Project	IEEE 802.16 Broadband Wireless Access Working Group < http://ieee802.org/16 >	
Title	Clean-up of TTG/RTG and Irregular Subframe in IEEE 802.16mSDD and Amendment Working Document	
Date Submitted	2009-01-05	
Source(s)	Jaeweon Cho, Hoky Choi, Samsung Electronics Co., Ltd.	+82-31-279-5796 jaeweon.cho@samsung.com
	Sean McBeath Huawei Technologies	smcbeath@huawei.com
	Mo-Han Fong Nortel Networks	mhfong@nortel.com
Re:	IEEE 802.16m-08/052, "Call for Comments and Contributions on Project 802.16m System Description Document (SDD)".	
	<ul style="list-style-type: none"> Target topic: Call for Comment on the SDD draft (IEEE 802.16m-08/003r6). 	
	IEEE 802.16m-08/053r1, "Call for Comments and Contributions on Project 802.16m Amendment Working Document".	
	<ul style="list-style-type: none"> Target topic: Call for Comment on Amendment Working Document Text (IEEE 802.16m-08/050). 	
Abstract	The contribution proposes to change TTG/RTG lengths and irregular subframe structure defined in the current 802.16m SDD draft and Amendment working document, in order that 802.16m BS shall smoothly support a mix of 802.16m and legacy MSs on the same RF carrier.

Clean-up of TTG/RTG and Irregular Subframe

Figure 25 Frame Structure with type-1 and type-2 subframes in TDD duplex mode (CP= $1/8 T_u$)

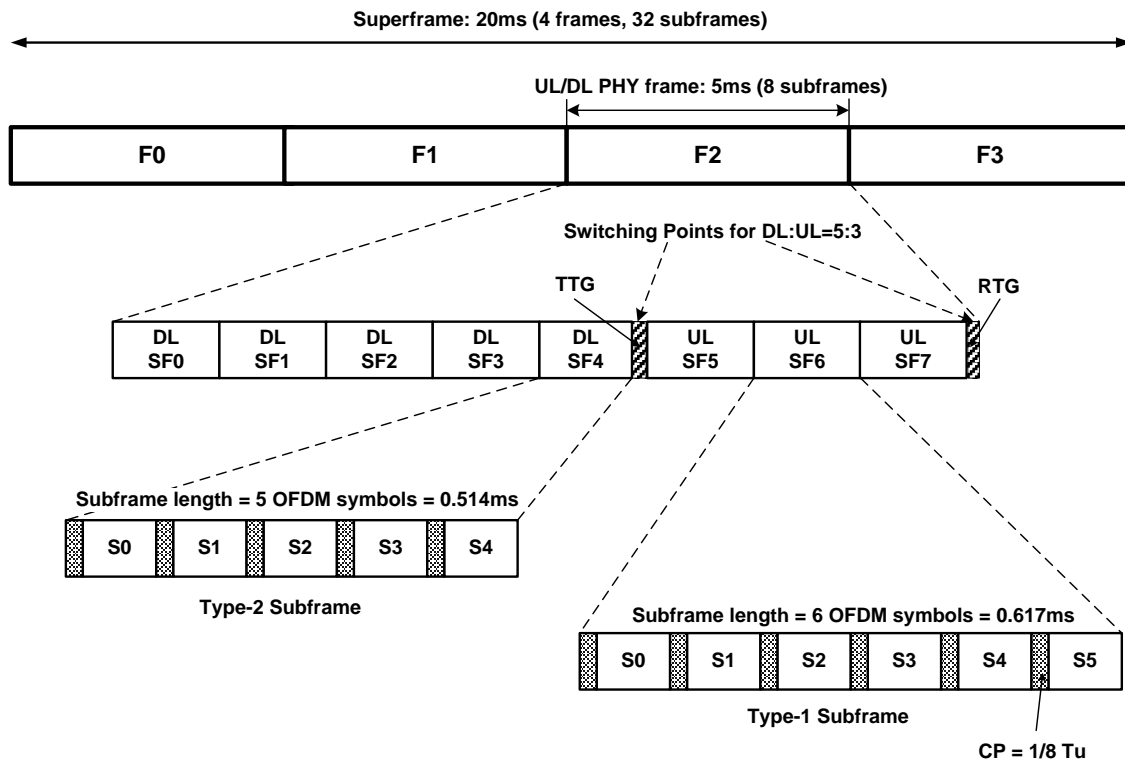
[Remedy 4: Replace Figure 25 in page 62 with the following Figure]

Figure 25 illustrates an example TDD frame structure with DL to UL ratio of 5:3. Assuming OFDMA symbol duration of $102.857\mu\text{s}$ and a CP length of $1/8 T_u$, the lengths of type-1 subframe and type-2 subframe are 0.617 ms and 0.514 ms , respectively. In Figure 25, the last DL subframe, i.e., DL SF4, is a type-2 short subframe whose last OFDMA symbol is an idle symbol to accommodate the gap required to switch from DL to UL.

Figure 27 TDD and FDD Frame Structure with CP of 1/16 T_u (DL to UL ratio of 5:3)

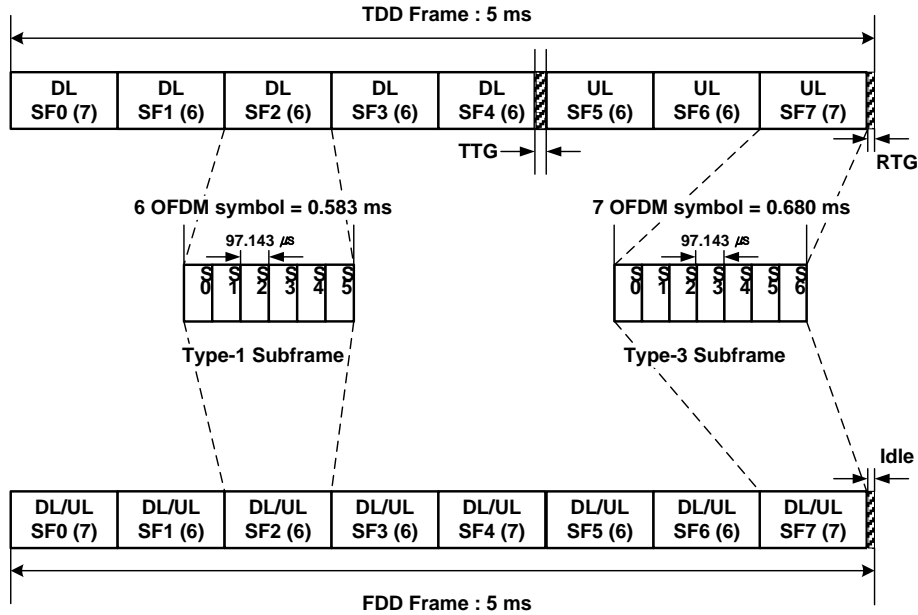
[Remedy 6: Replace Figure 27 in page 63 with the following Figure]

For nominal channel bandwidths of 5, 10, and 20 MHz, an IEEE 802.16m frame for a CP of $1/16 T_u$ shall have five type-1 subframes and three type-2 subframes for FDD, and six type-1 subframes and two type-3 subframes for TDD.

Figure 27 illustrates an example of TDD and FDD frame structure with a CP of $1/16 T_u$. Assuming OFDM symbol duration of $97.143\mu\text{s}$ and a CP length of $1/16 T_u$, the length of type-1 and type-2 subframes are 0.583 ms and 0.680 ms , respectively. Other numerologies may result in different number of subframes per frame and

Figure 391 Frame Structure with type-1 and type-2 subframes in TDD duplex mode for 5, 10, 20 MHz channel bandwidths (CP=1/8 T_b)

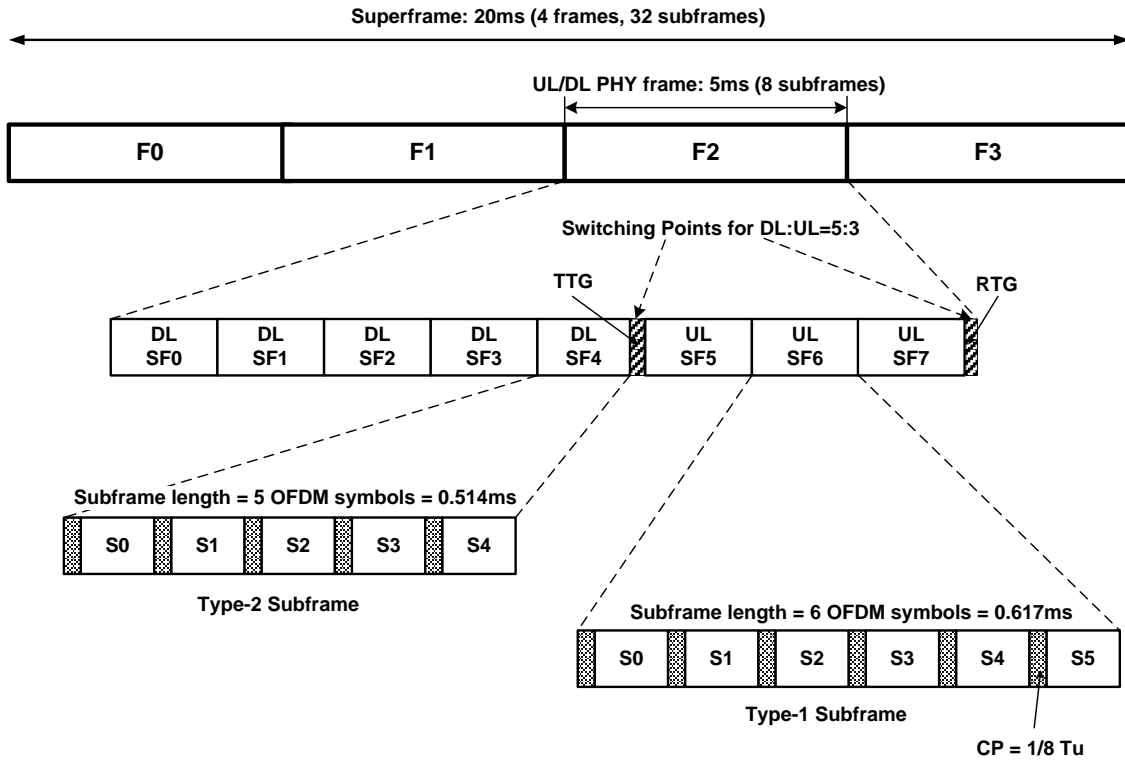
[Remedy 4: Replace Figure 391 in page 17 with the following Figure]

Figure 391 illustrates an example TDD frame structure with D:U = 5:3, which is applicable to the nominal channel bandwidths of 5, 10, and 20 MHz with $G = 1/8$. In Figure 391 the last DL subframe, i.e. DL SF4, is a type-2 subframe and the other subframes are type-1 subframes.

Figure 392 TDD and FDD Frame Structure with CP of $1/16 T_b$ (DL to UL ratio of 5:3)

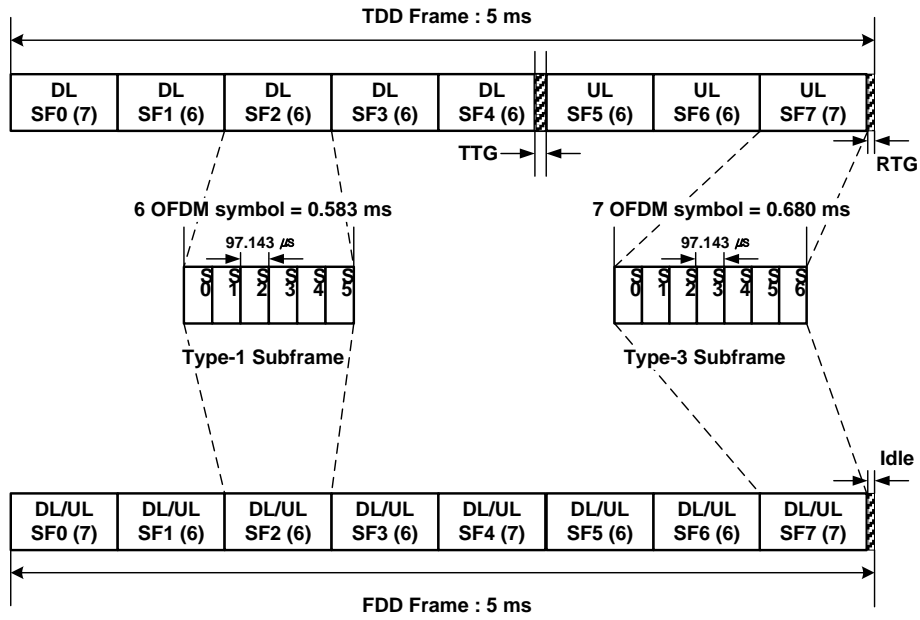
[Remedy 6: Replace Figure 392 in page 18 with the following Figure]

392 illustrates an example of TDD and FDD frame structure with a CP of 1/16 T_b . Assuming OFDMA symbol duration of 97.143 μ s and a CP length of 1/16 T_b , the length of type-1 and type-23 subframes are 0.583 ms and 0.680 ms, respectively.
